Apex House- Plymouth Grove

Pre- Commencement Planning conditions

Condition 9

REF: 13294/FO/2023

Appendix E- Drainage Details

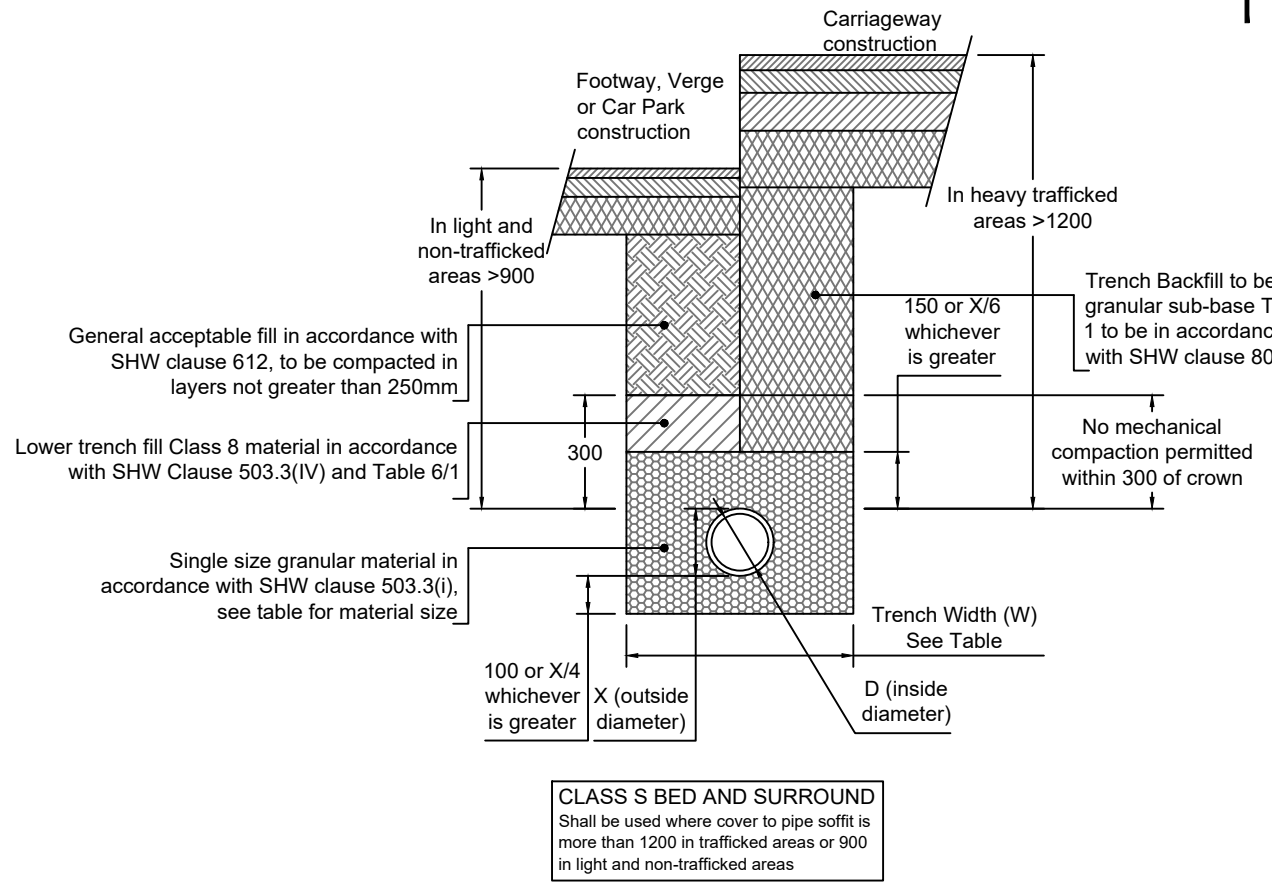
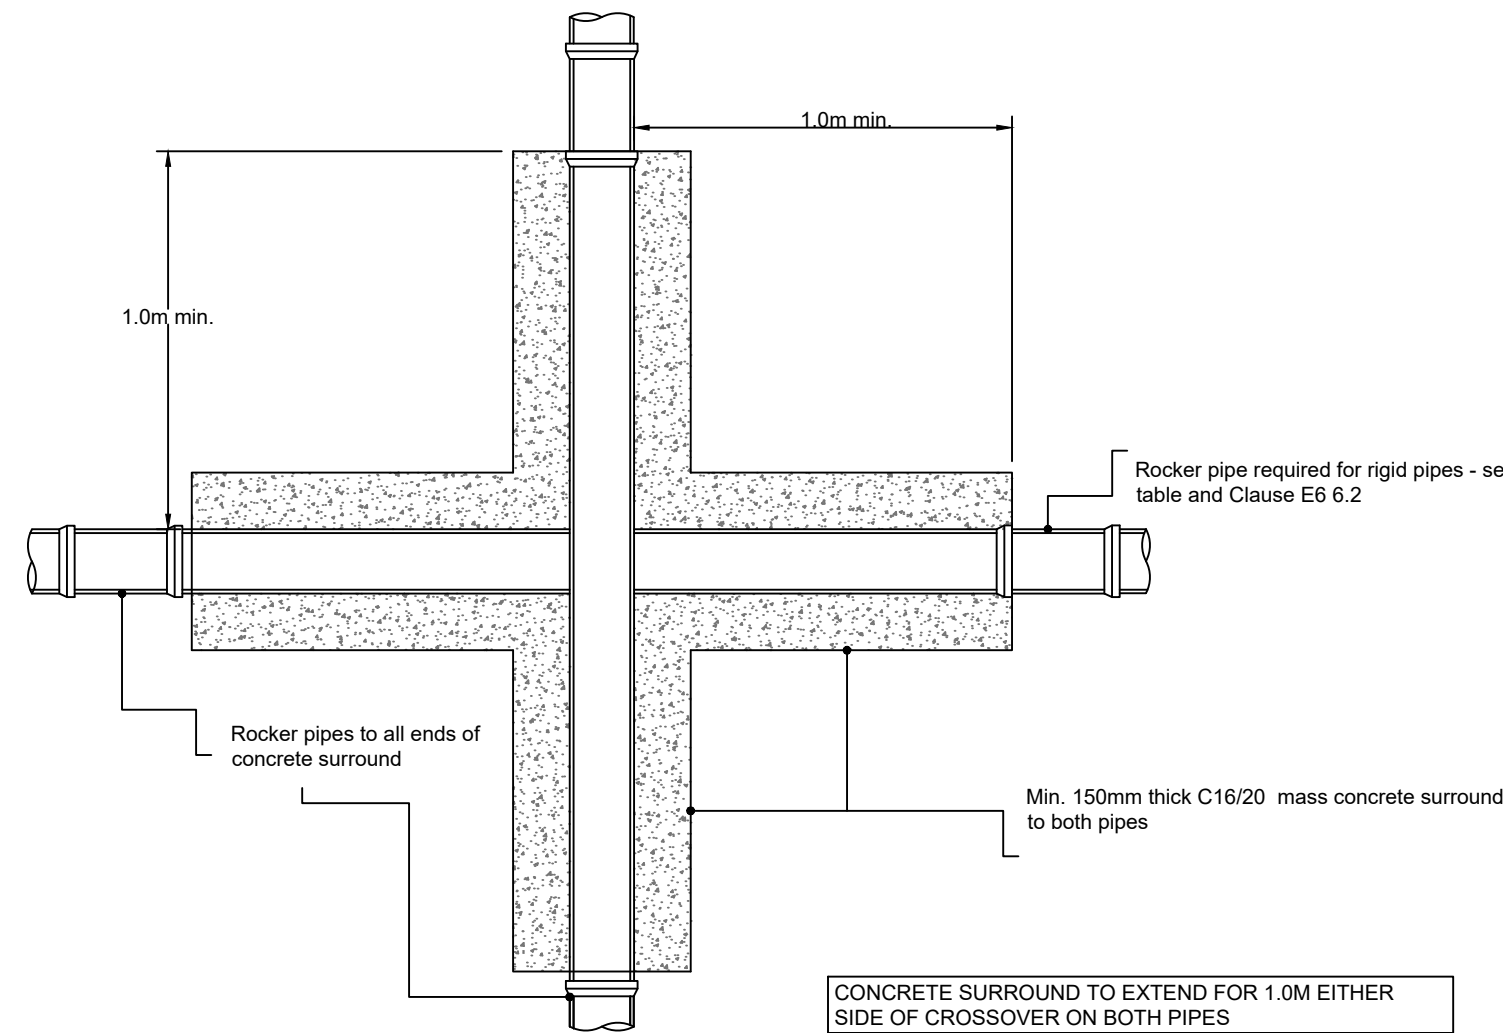
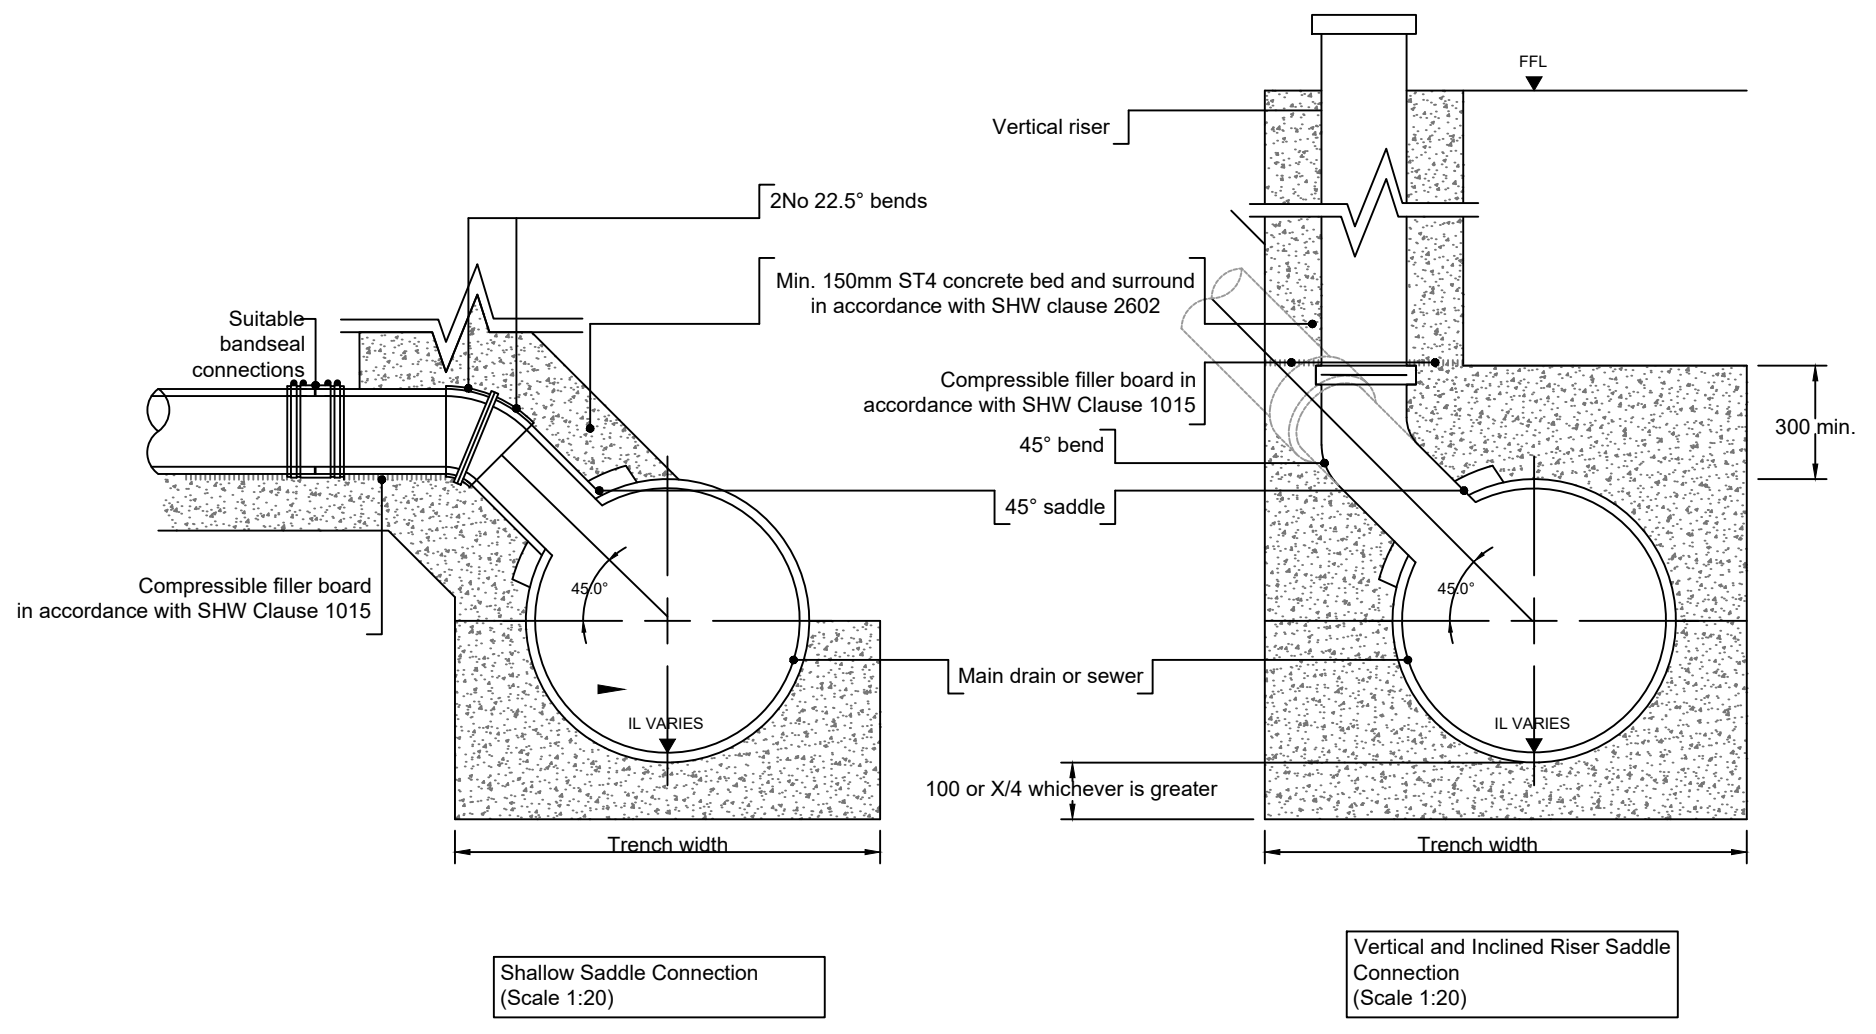
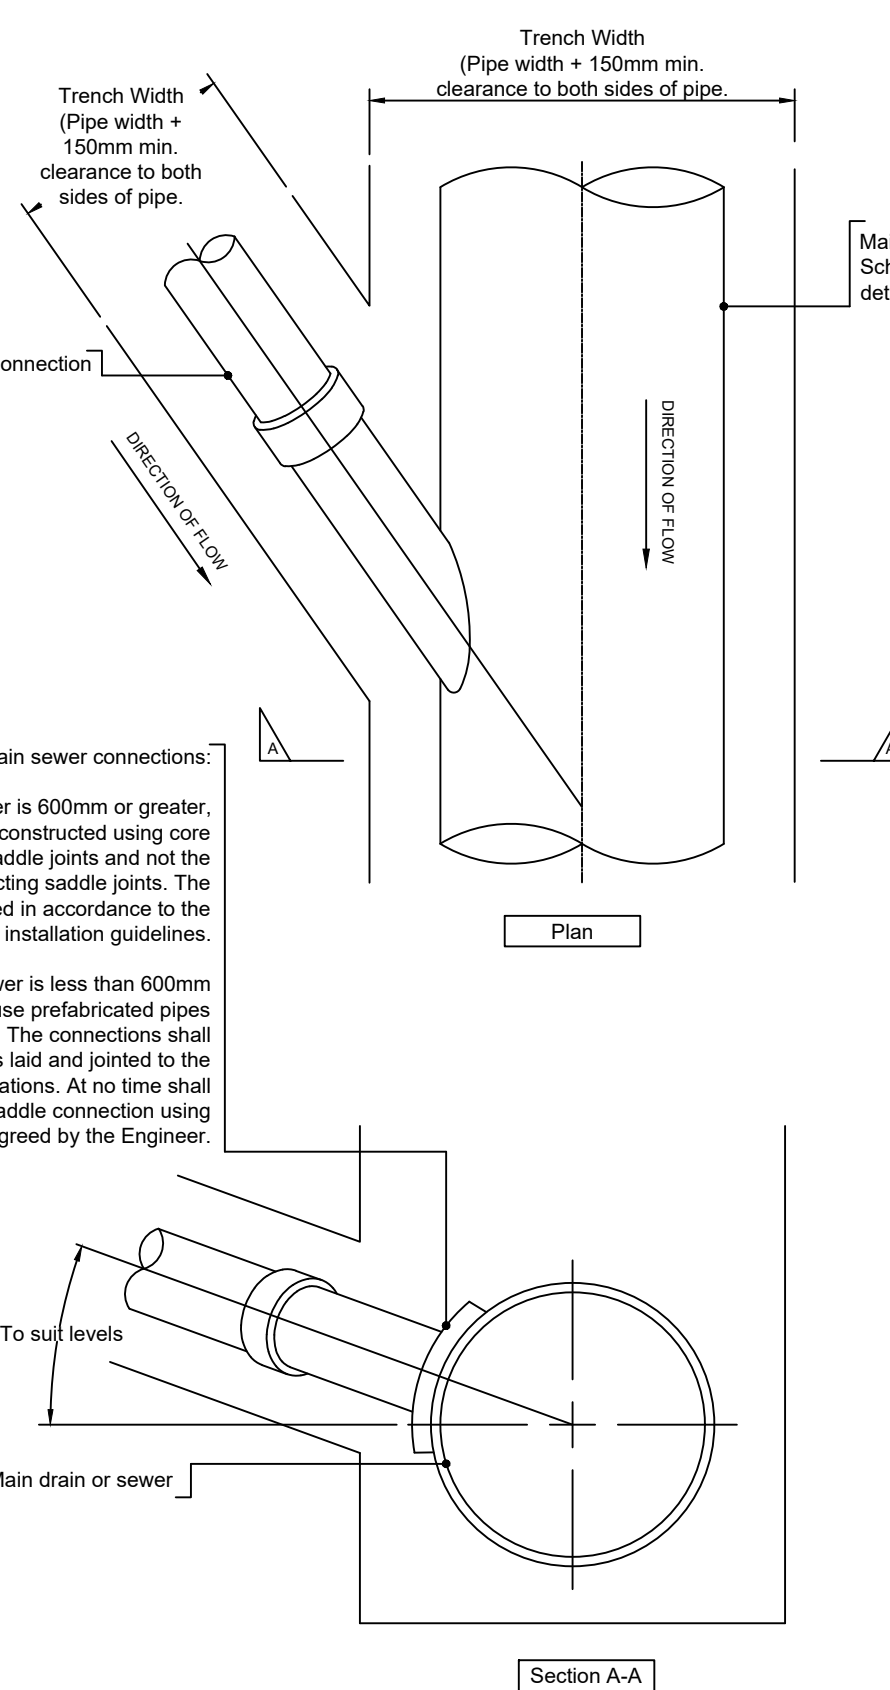
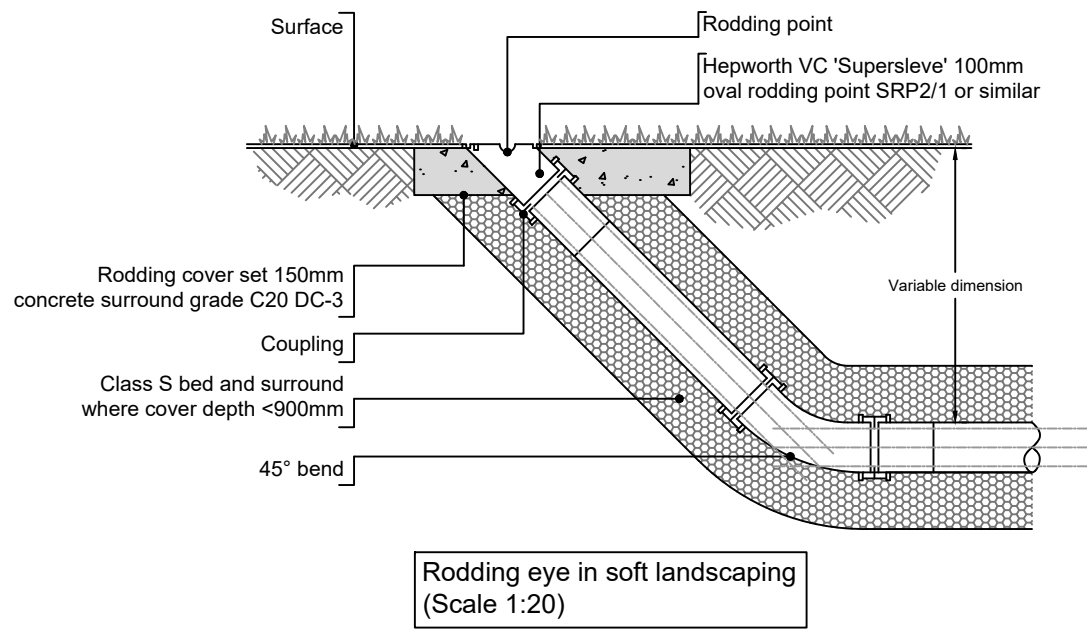
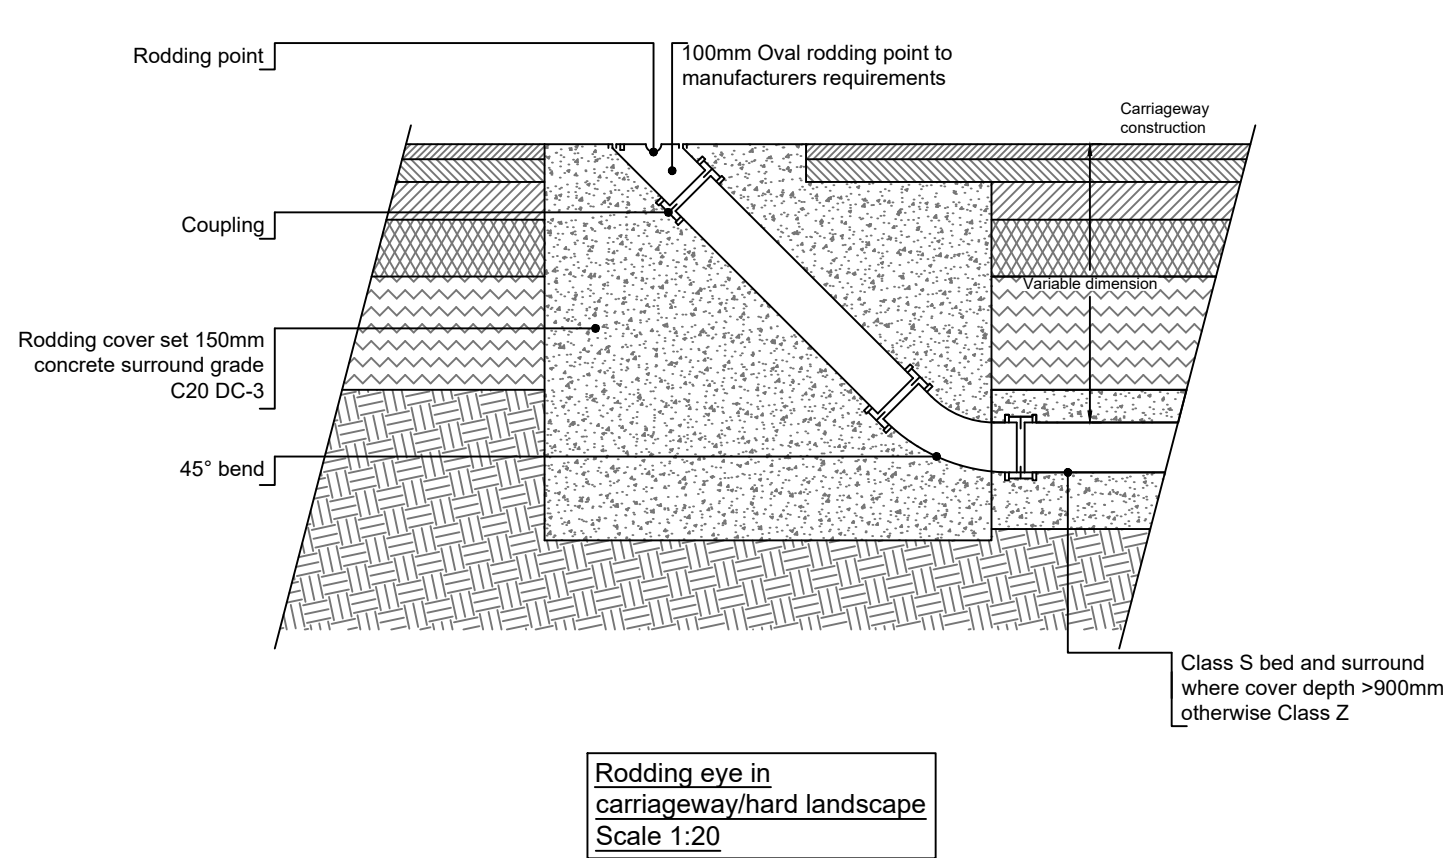
1. Construction details of flow control and SuDS elements.

Drainage details have been attached in Appendix E.
